PRODUCT / PROCESS CHANGE NOTIFICATION

1.1 Company	 STMicroelectronics International N.V
1.2 PCN No.	MDG/24/14661
1.3 Title of PCN	JSCC (China) UFQFPN 7X7 48L new BOM for STM32U53/545x STM32U57/585x listed products.
1.4 Product Category	STM32U535x STM32U545x, STM32U575x, STM32U585x
1.5 Issue date	2024-04-11

PCN14661 – Additional information

JSCC (China) UFQFPN 7X7 48L new BOM for STM32U53/545x STM32U57/585x listed products.

What are the changes?

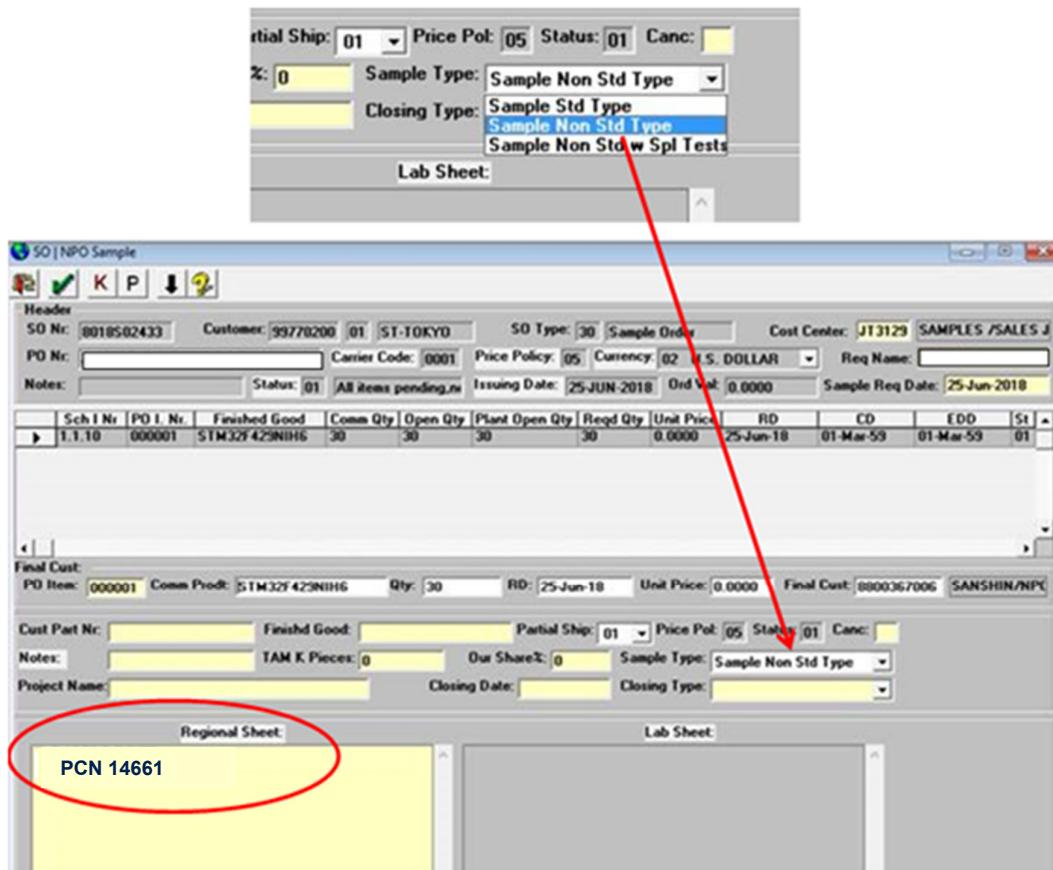
Changes described in table below:

Existing back-end line	Added back-end line
Assembly site	StatsChipPAC JSCC Jiangyin (China)	
Molding Compound	SUMITOMO G770	Sumitomo G631BQ-CJ
Wire	Gold 0.8mil	Copper Palladium 0.8mil
